### AGENDA

#### WASHINGTON COUNTY PLANNING COMMISSION REGULAR MEETING August 5, 2019, 7:00 PM WASHINGTON COUNTY ADMINISTRATIVE COMPLEX 100 WEST WASHINGTON STREET 2ND FLOOR, PUBLIC MEETING ROOM #2000

<u>Cascade Towne Center Phase IA</u> [PC-19-001] – Concept plan for 36 proposed semi-detached townhome lots consisting of 4 acres of residential development located along both sides of North Boyd Street; Zoning: SED (Special Economic Development); Planner: Ashley Holloway \*

### WASHINGTON CO. PLAN REVIEW DEPT. - ENGINEERING REVIEW

D-6260

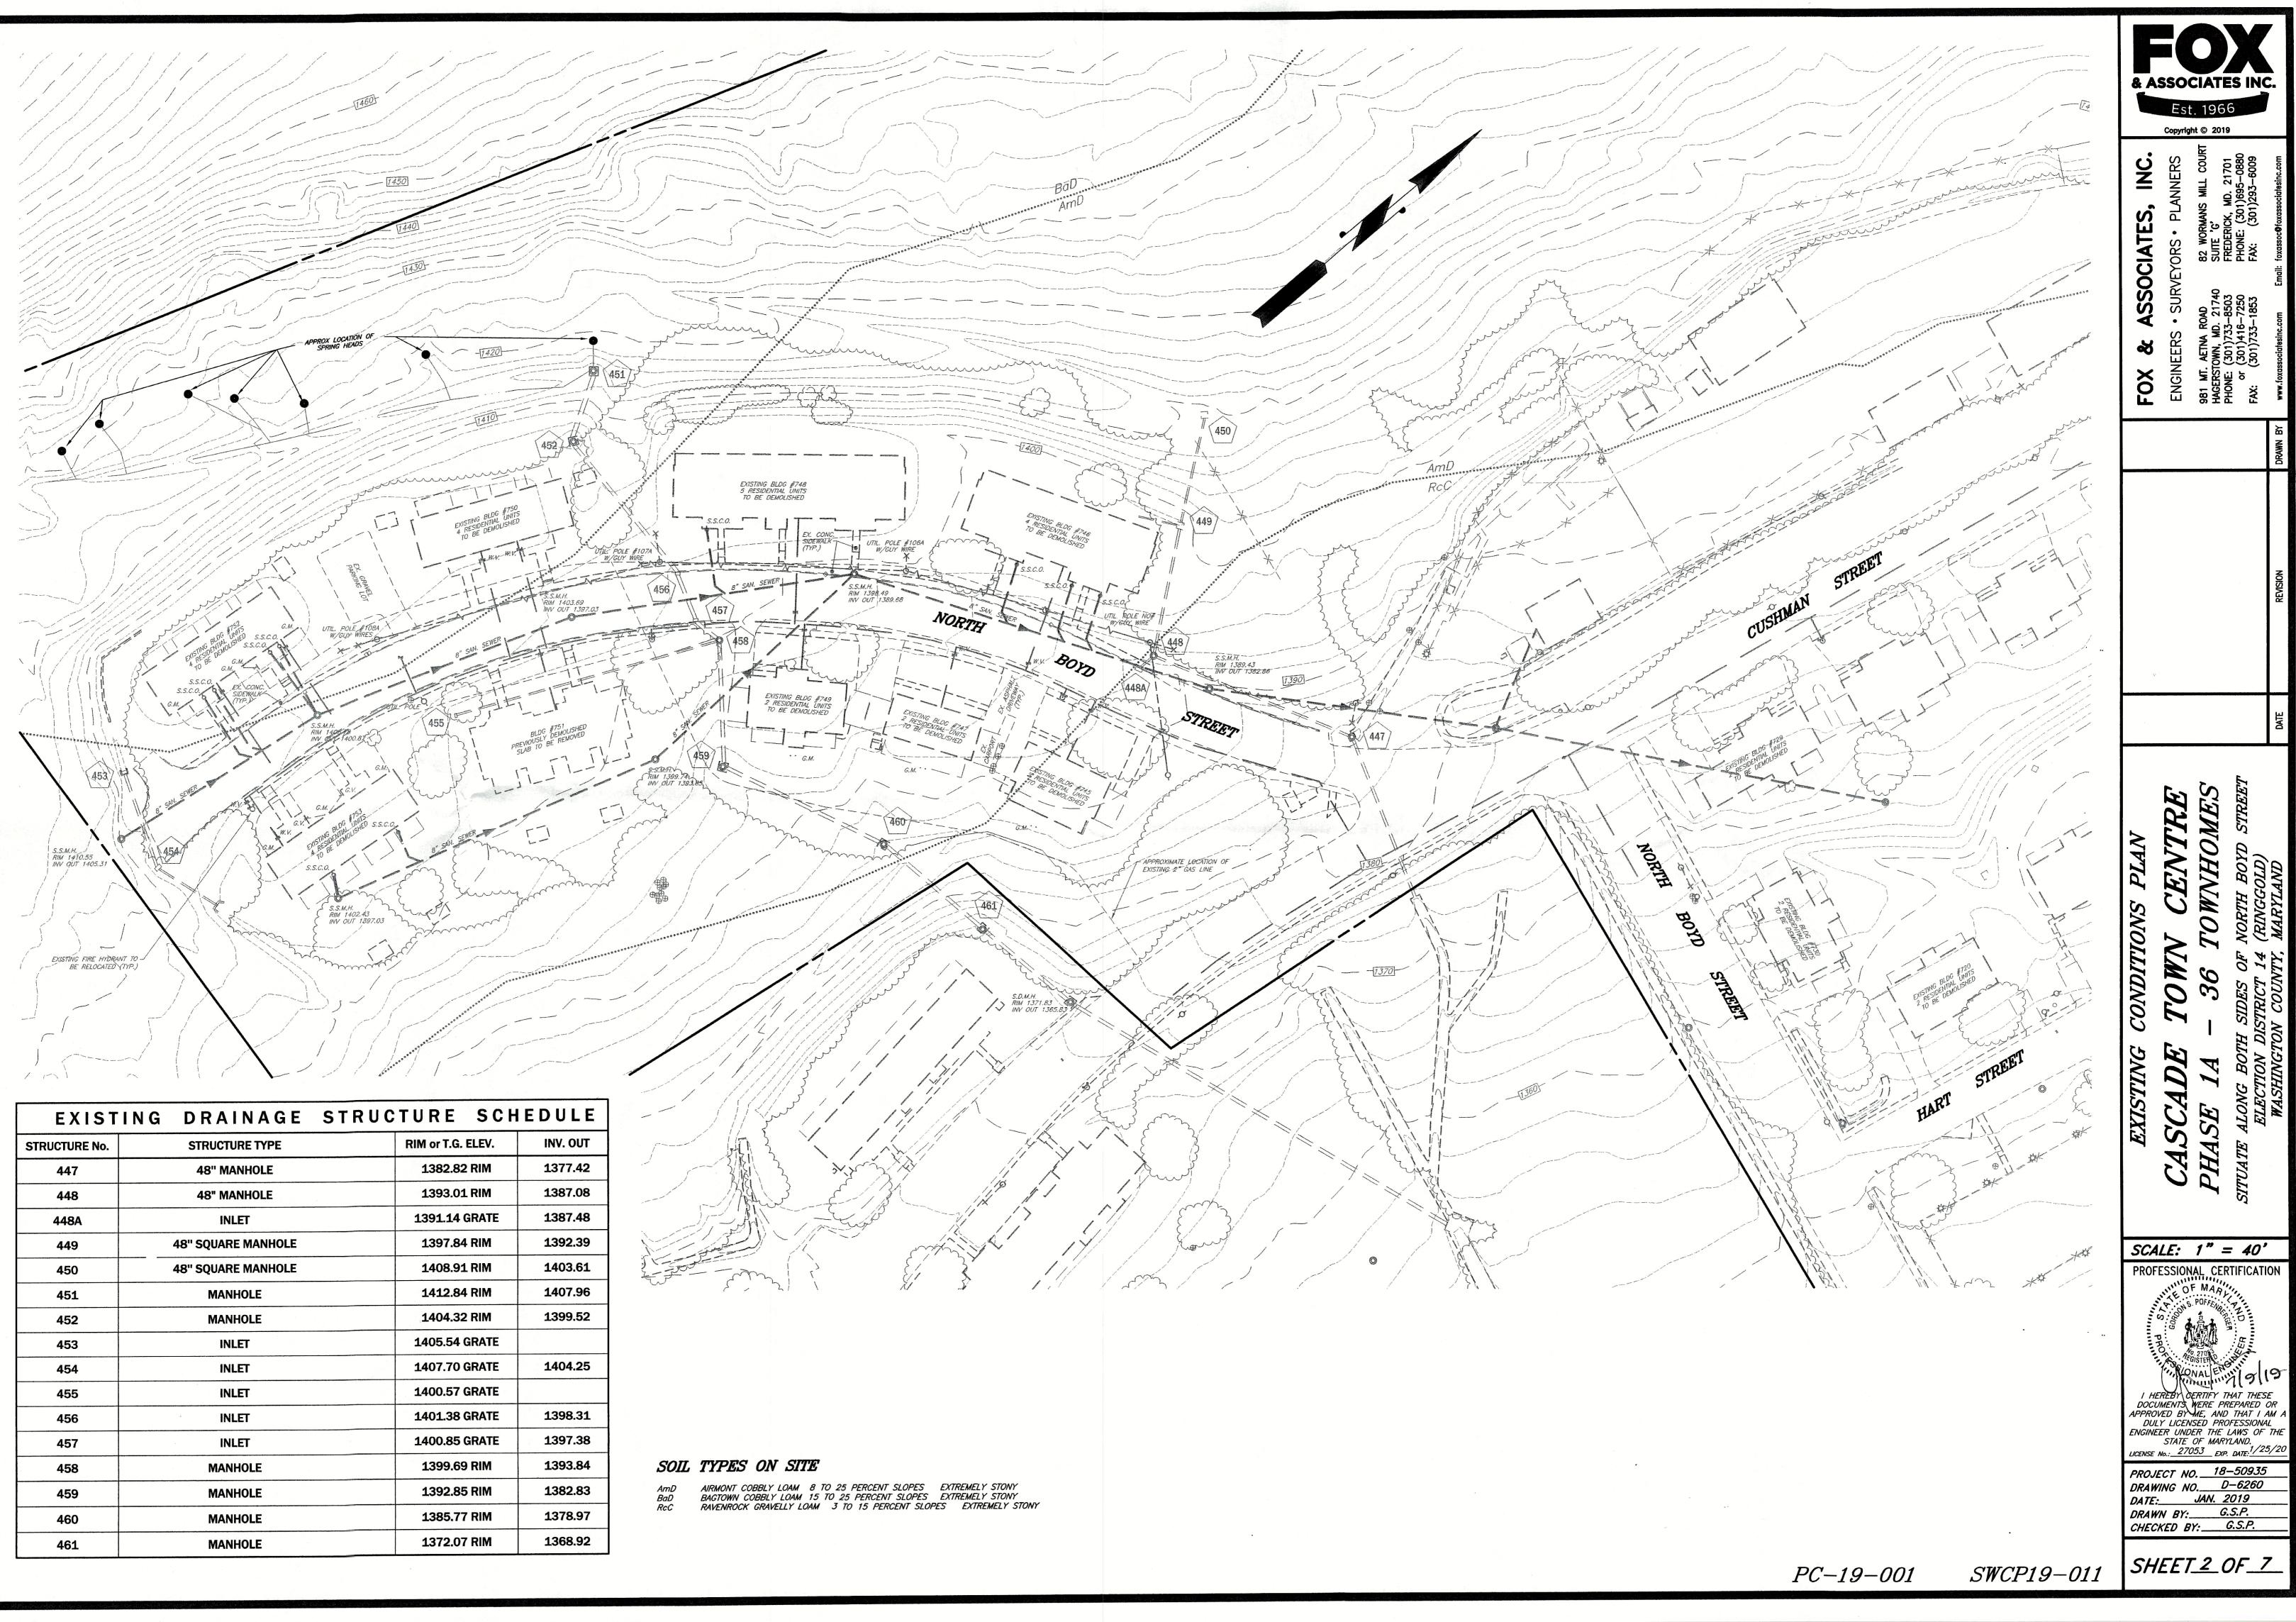
- 9. Title Sheet. Gate 2 is identified on the plan as the "Main Entrance", is this correct? Gate 2 is currently closed to traffic.
- 10. Sheet 3. If the existing sewer system is to be replaced, the County may require a complete rebuild of the existing roadway within the project area.

- 9. Title Sheet. Gate 2 is identified on the plan as the "Main Entrance", is this correct? Gate 2 is currently closed to traffic.
- 10. Sheet 3. If the existing sewer system is to be replaced, the County may require a complete rebuild of the existing roadway within the project area.
